14 CFR Part 39

[Docket No. 95-NM-22-AD]

Airworthiness Directives; Boeing Model 747-100, -200, -300, and SP Series Airplanes**AGENCY:** Federal Aviation Administration, DOT.**ACTION:** Notice of proposed rulemaking (NPRM).

Figure 4

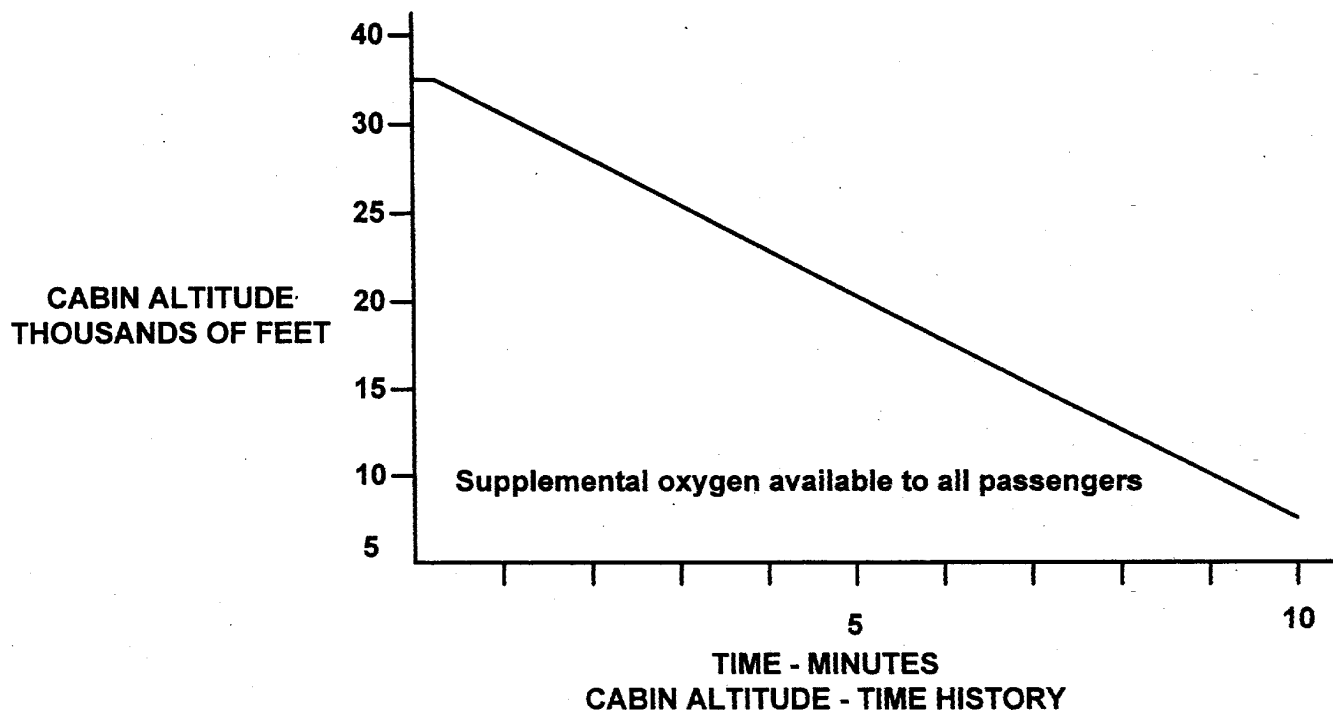
NOTE: For figure 4, time starts at the moment cabin altitude exceeds 8,000 feet during depressurization. If depressurization analysis shows that the cabin altitude limit of this curve is exceeded, the following alternate limitations apply: After depressurization, the maximum cabin altitude exceedence is limited to 40,000 feet. The maximum time the cabin altitude may exceed 25,000 feet is 2 minutes; time starting when the cabin altitude exceeds 25,000 feet and ending when it returns to 25,000 feet.
